## R03HB

# Seat Frame Anchorage

RECALL CAMPAIGN RO3HB

## ISSUE

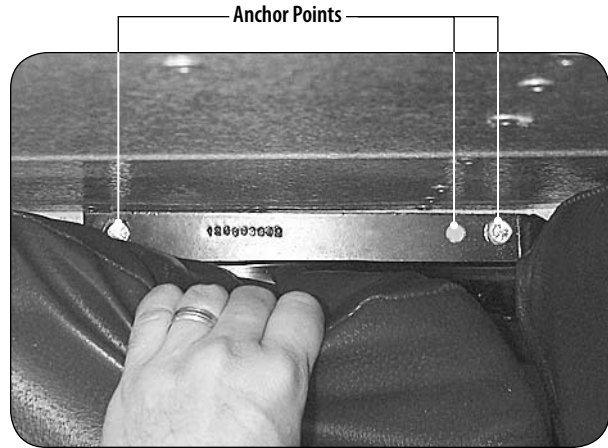
Seat frame to ledge anchoring may be missing anchor bolts.

Inspection of each seat frame to ledge anchoring point and installation of additional bolts as necessary. Three bolts are required.

Anchor Point Inspection

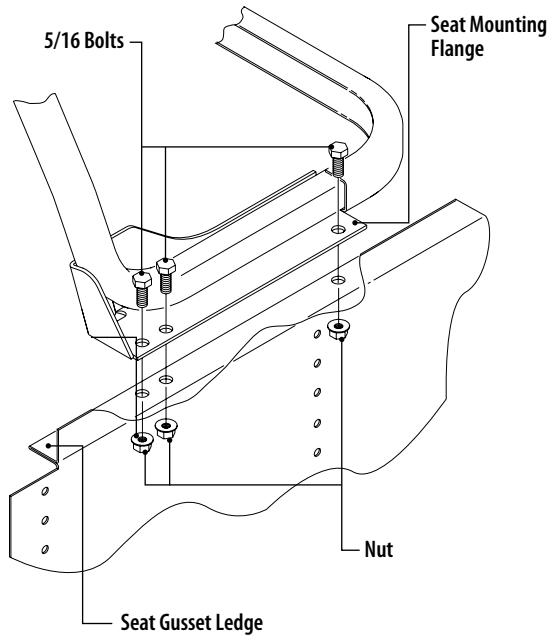
- 1 Inspect each seat frame mounting flange to wall anchoring point. Compress the seat cushion for adequate inspection. If three (3) bolts are found, **STOP**. If not, proceed to step #2.
- 2 Back drill 11/32 inch diameter hole through seat gusset ledge where required by seat frame mounting flange .
- 3 Install 5/16 - 18 x 3/4 inch bolt, BB #1032283 and nut, BB #0829390 as required. Torque bolt(s) to 18 - 20 ft. lbs.
